CITY OF ALBUQUERQUE

March 24, 2023

Re: Veterans Integration Center
2701 Mulberry St. SE
Traffic Circulation Layout
Architect's Stamp XX-XX-XX (M15-D054)

AS-1.00

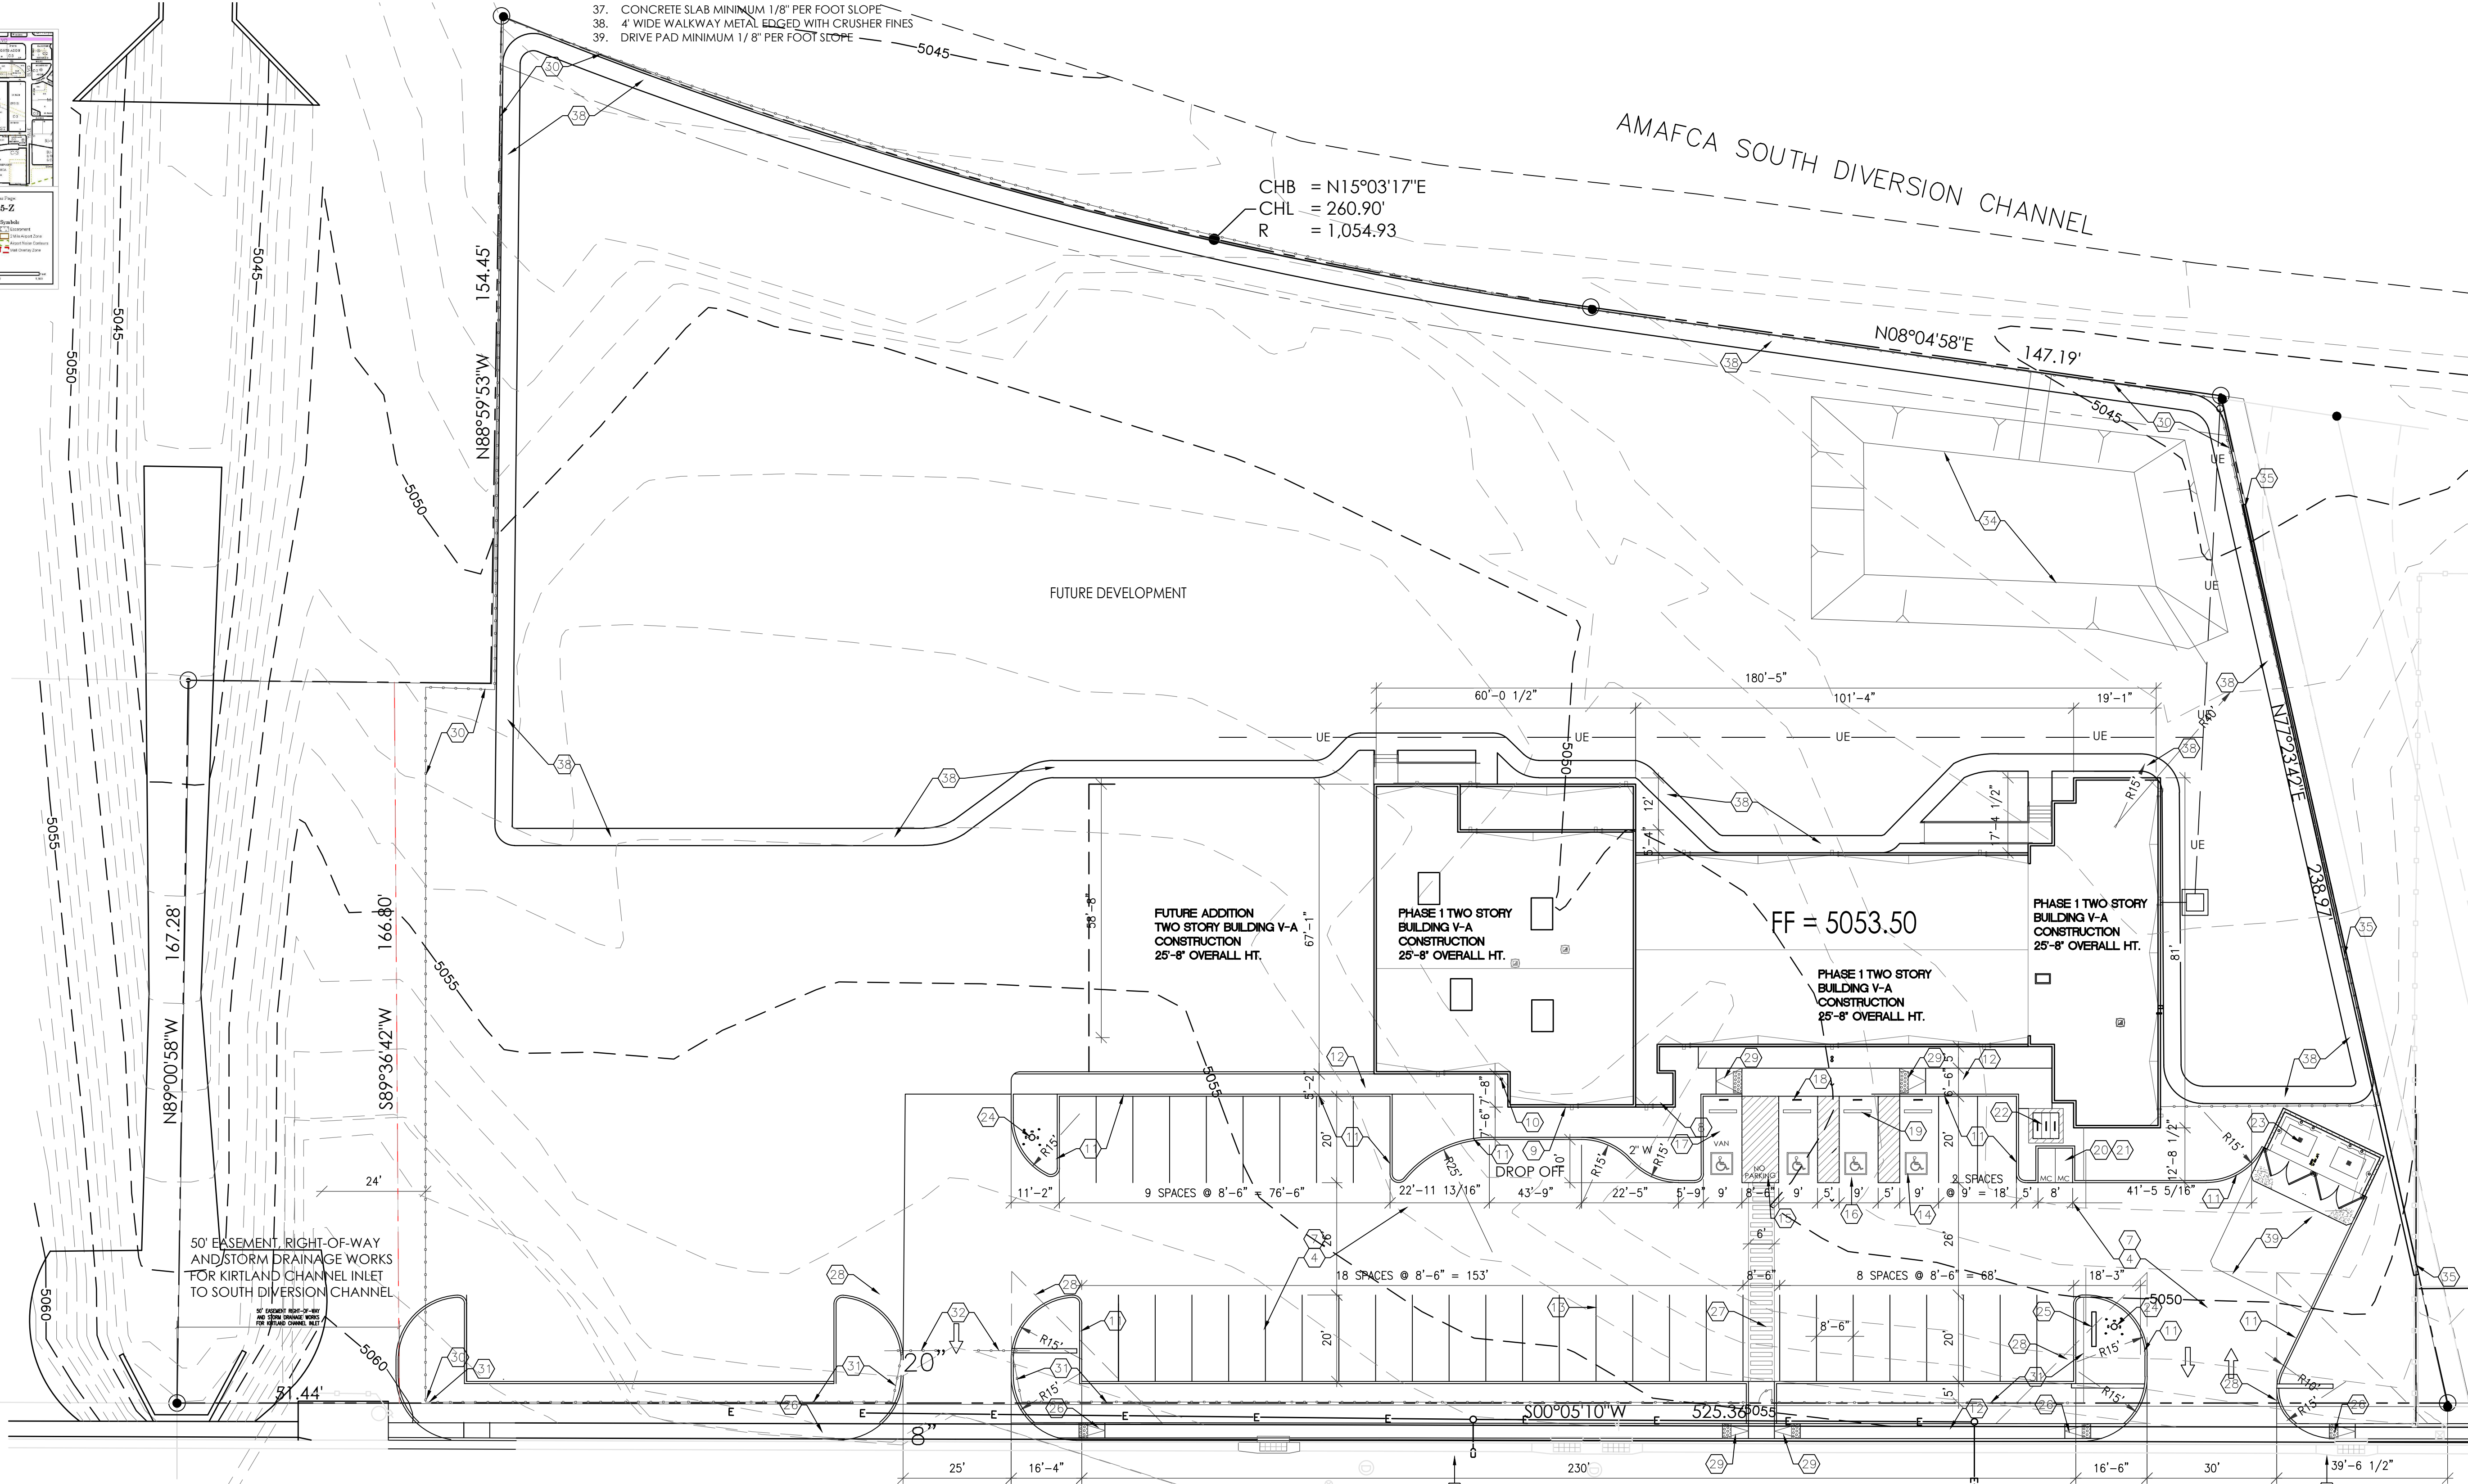
1. Identify the right of way width, medians, curb cuts, and street widths on Mulberry St.
2. Please define the property line.
3. Please provide a date on the Architect stamp.

4. Provide the existing sidewalk width.
5. Please show on the site plan the main building entrance.
6. Is there a third access at the south side of the site? If so, please provide details such as radii and access width.

7. Key note 28: detail A15 is missing.
8. Show the clear sight triangle and add the following note to the plan: "Landscaping and signage will not interfere with clear sight requirements. Therefore, signs, walls, trees, and shrubbery between 3 and 8 feet tall (as measured from the gutter pan) will not be acceptable in the clear sight triangle.

9. Please show on the site plan the word "NO PARKING" on each ADA aisle.
10. Provide a copy of Fire Marshal approval.
11. On the details sheet, please provide Transportation details only. We stamp and approve transportation details only.

12. Please specify the City Standard Drawing Number when applicable.
13. Add a note stating "All broken or cracked sidewalk must be replaced with sidewalk and curb & gutter." A build note must be provided referring to the appropriate City Standard drawing.
